Additional features needed in RAP

Karl Weber

EtherCAT
Technology Group

Figure
Does not show
Real Numbers!

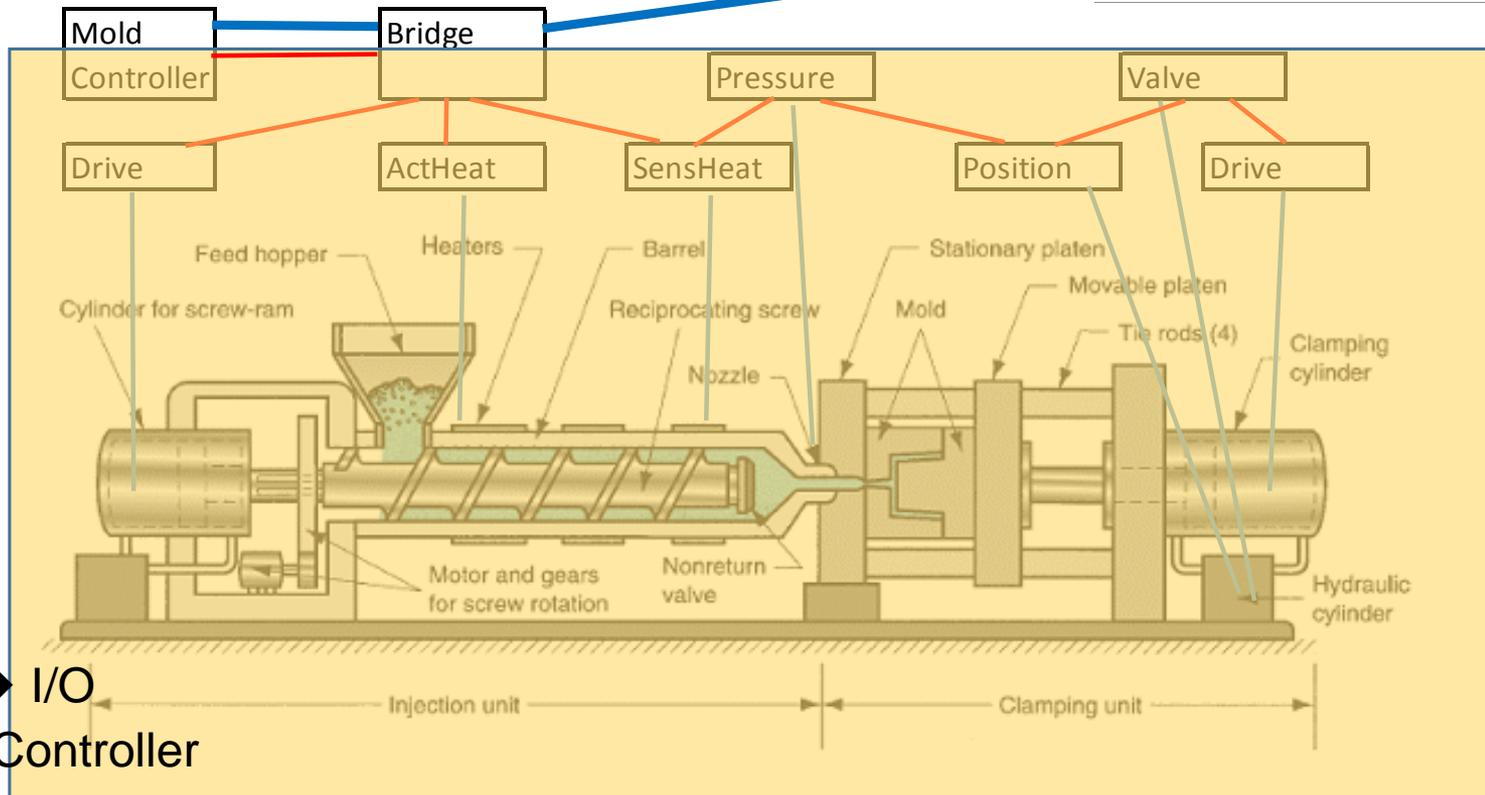
Per Machine

500 I/O

30 I/O Terminals

Per Cell

20 Machines

Reverse roles:

Small Servers → I/O

Large Client → Controller

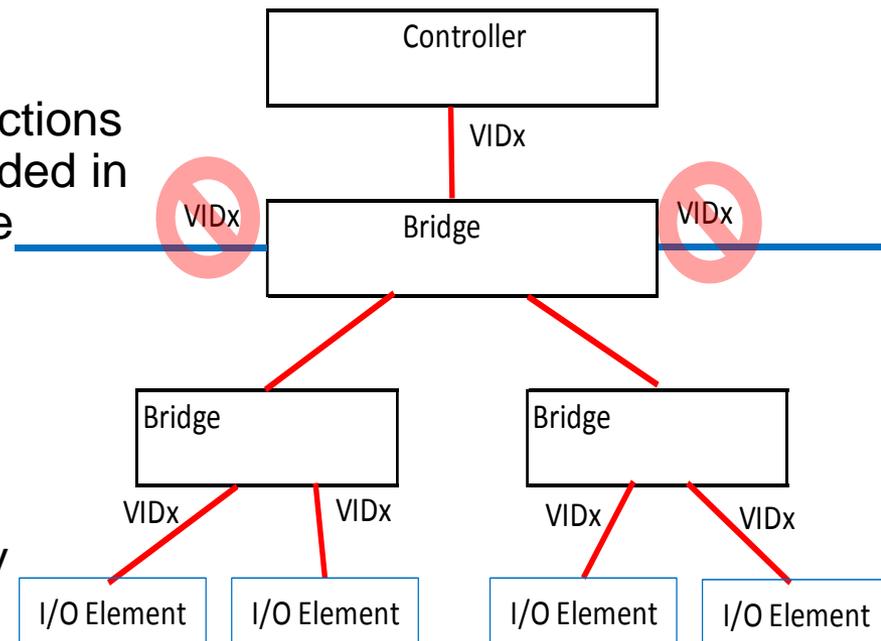
- Logically isolated network**

- =Data flow to devices could be done without controller interactions
 - =Allows access to devices with a few restrictions
 - =Just a single communication channel needed in
 - But a very predictable communication cycle
